**City of Millersburg  
DECISION**

**File No: SP 25-01 Construction Equipment Storage**

**Proposal:** The applicant is proposing to locate a construction equipment storage yard on property that already contains an office building for the construction business. The yard will be about 1.5 acres.

Sheet **C103**  
SCALE: SEE BARSCALE

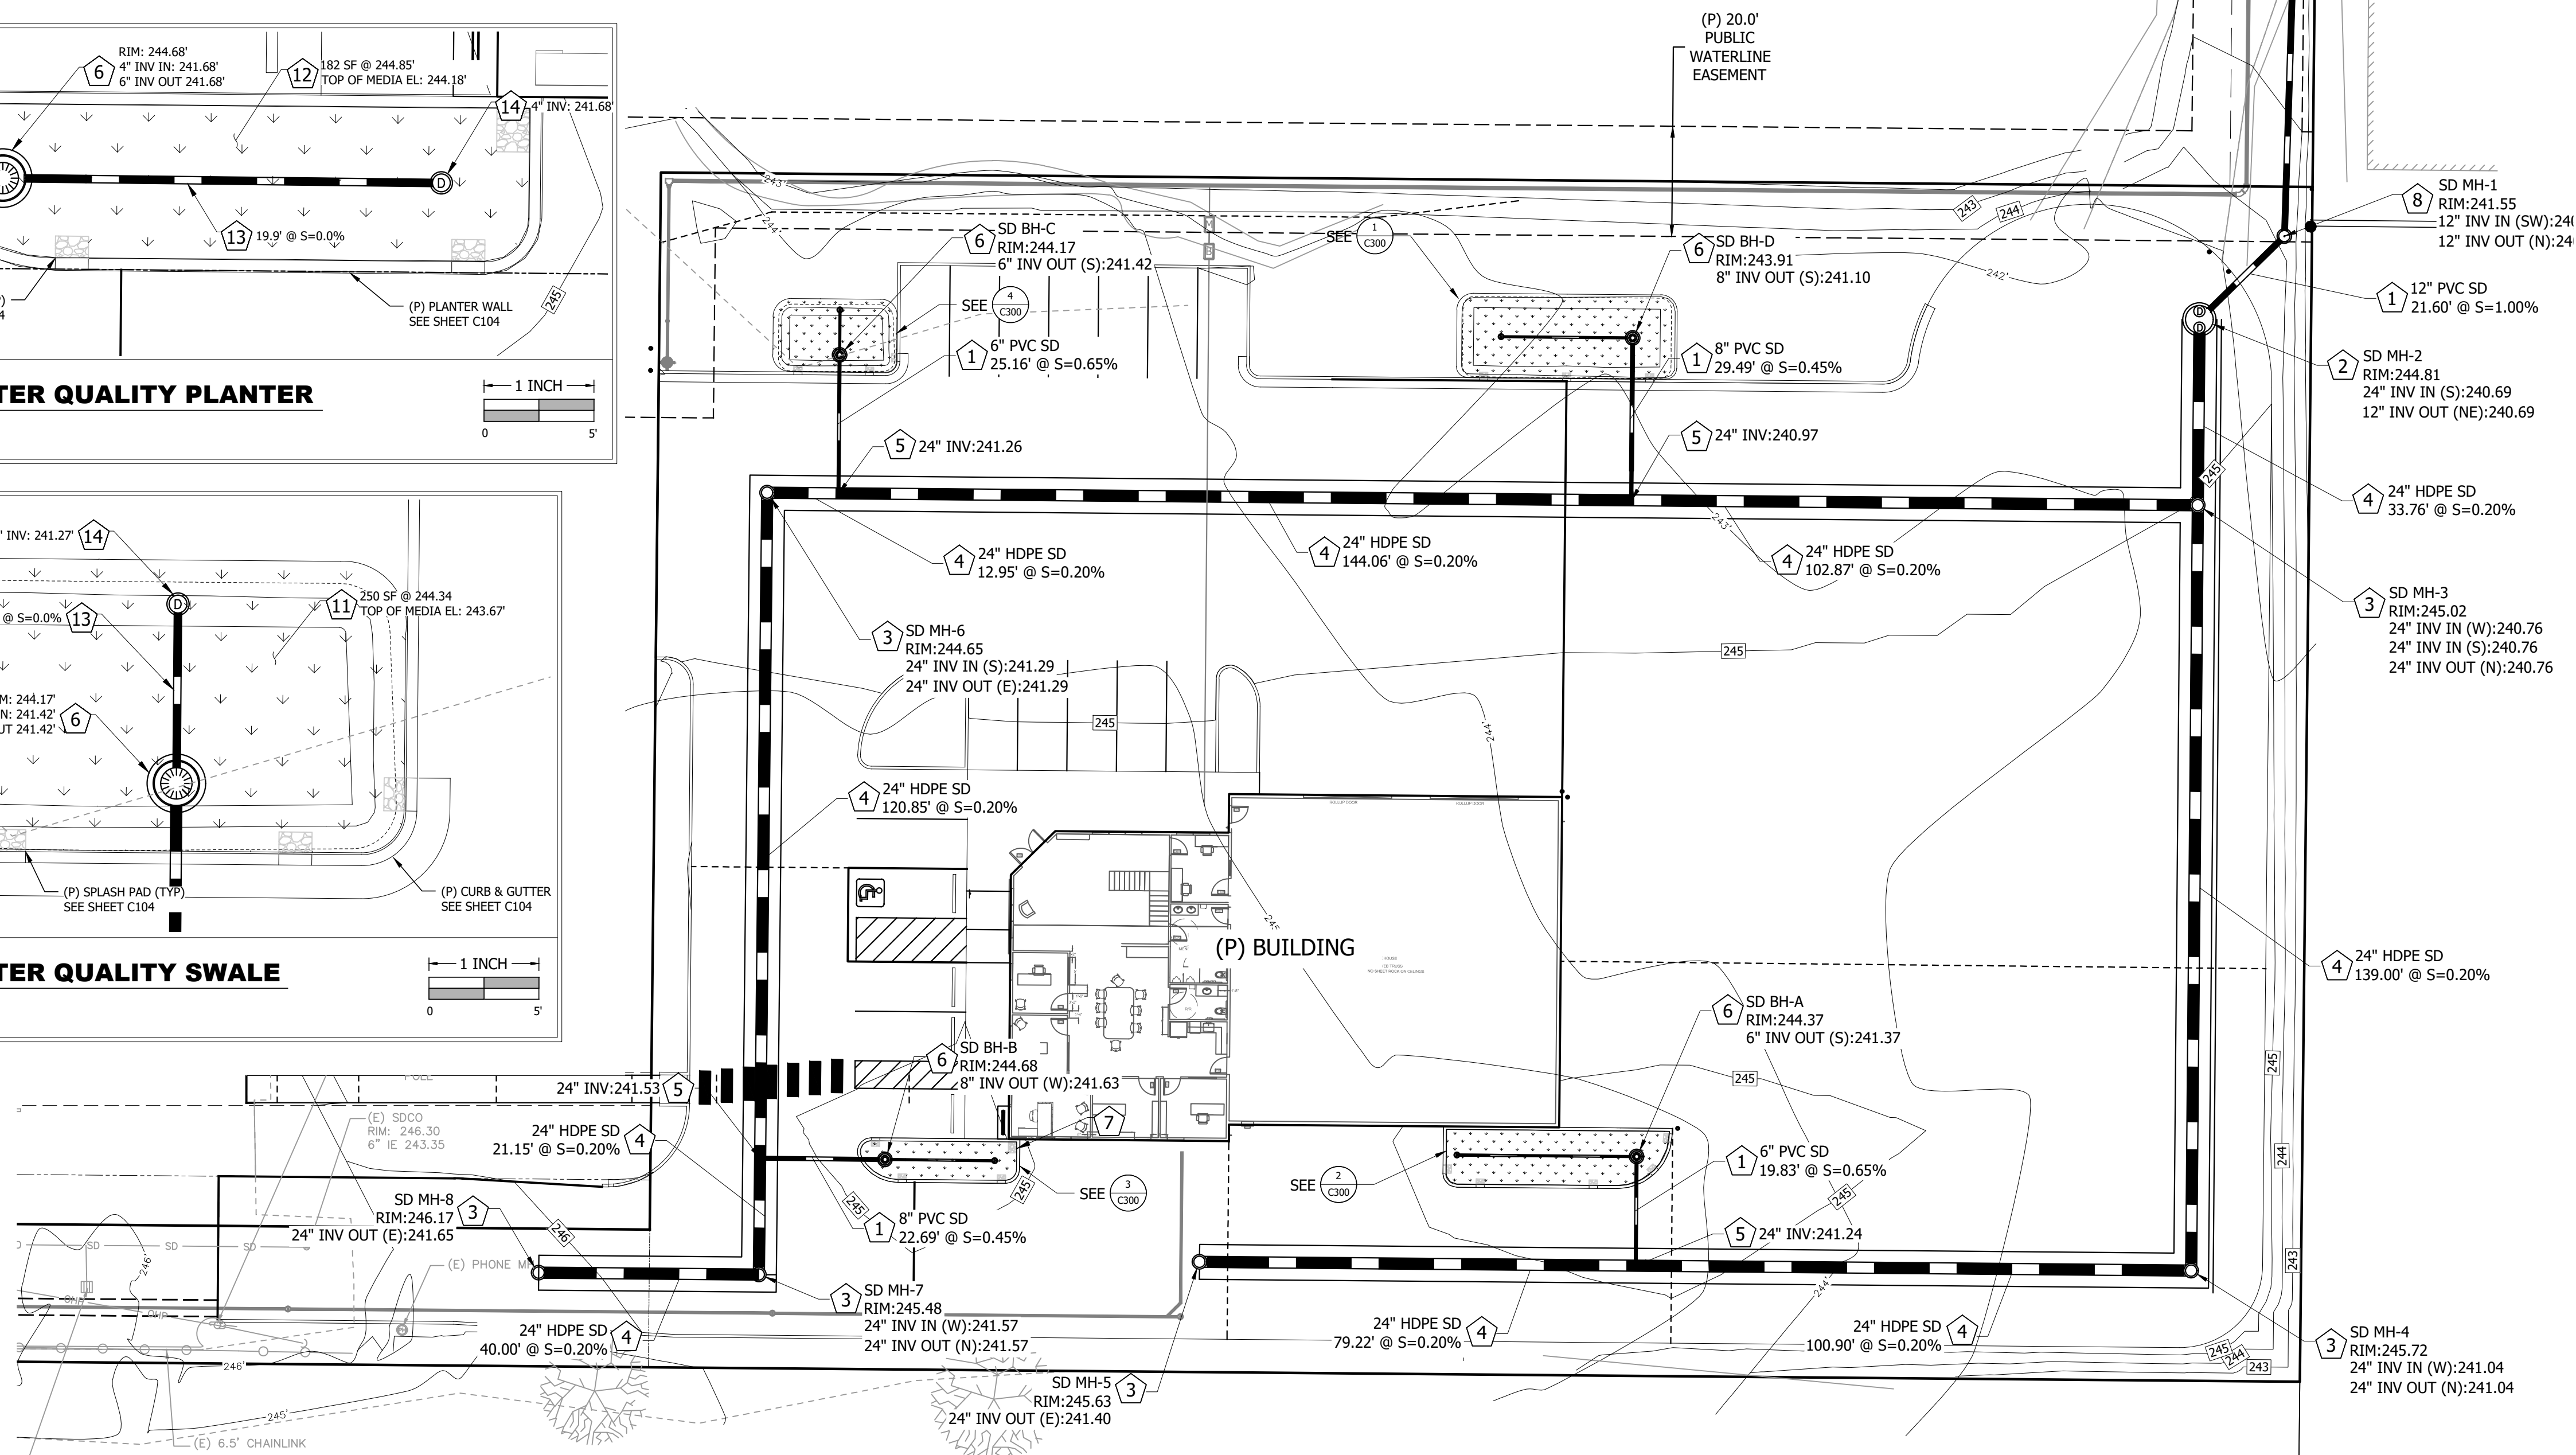
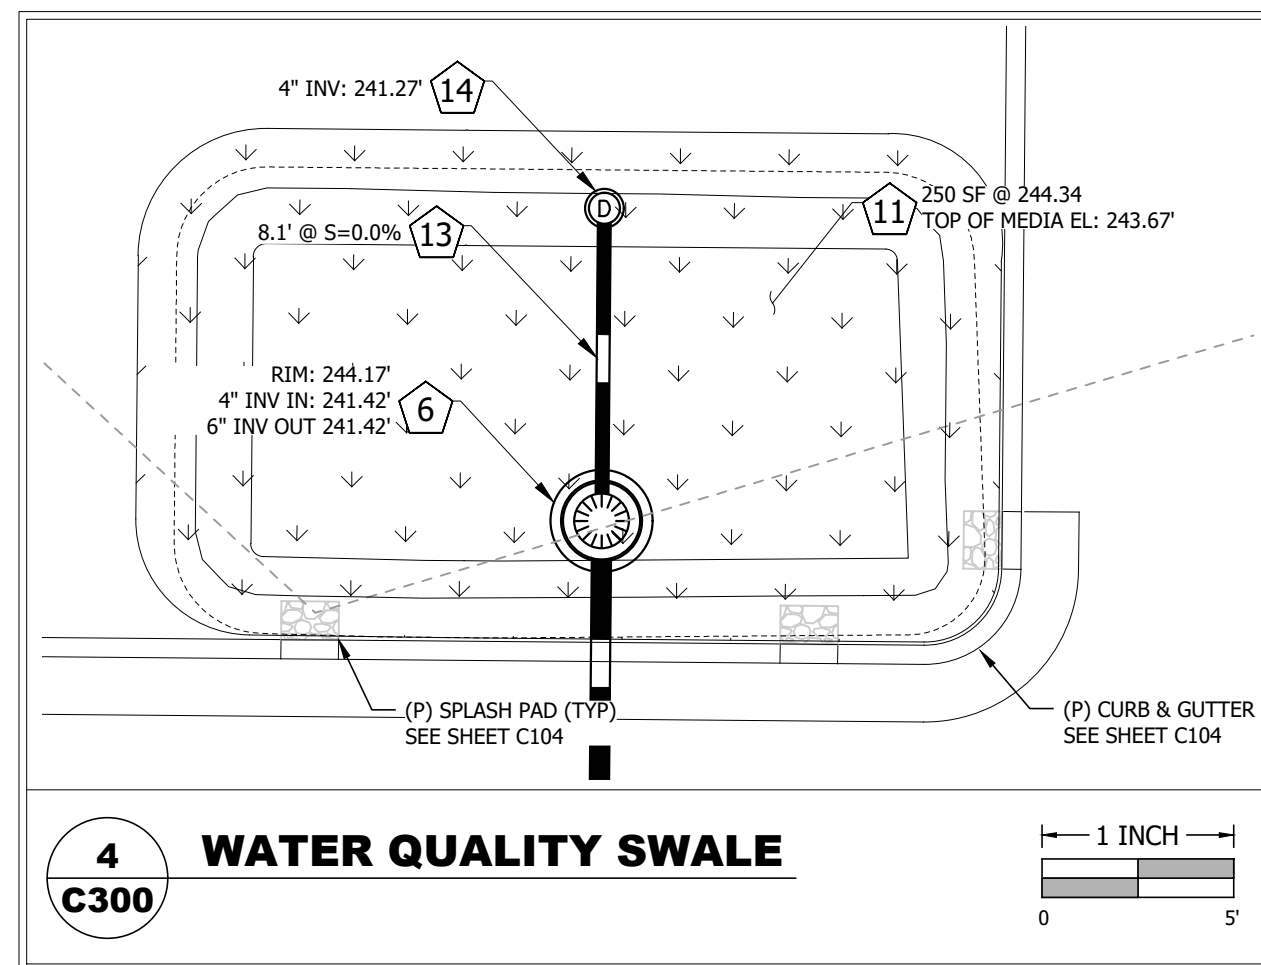
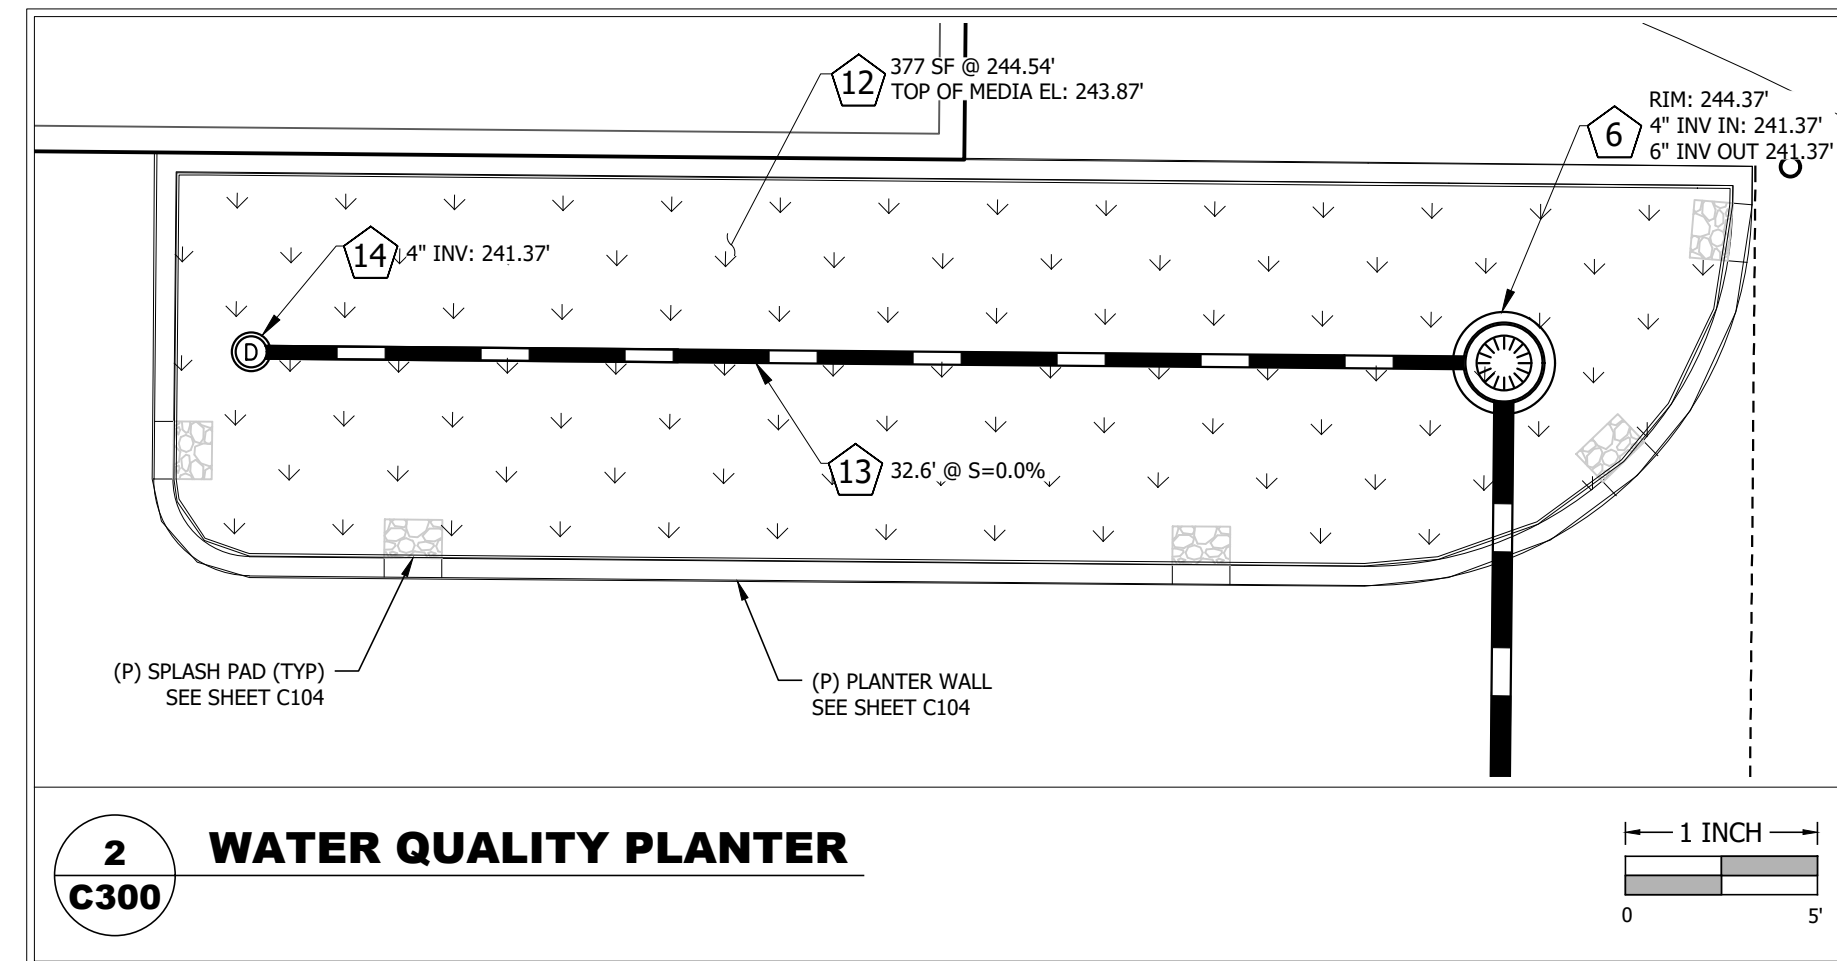
**The site plan reviewed for this meeting did not clearly indicate that a security fence or road access gate is going to be provided; however, the fire department anticipates that this will be a design feature of this project. If this gate is going to be an automatic opening type, the automatic gate opener shall be capable of being activated by all the following:**

- 1. An approved OPTICOM sensor,**
- 2. A Knox key switch, and;**
- 3. A manual means in the event of power/mechanical failure. This shall include an adjacent pedestrian gate with a Knox-style lock to provide firefighter access.**
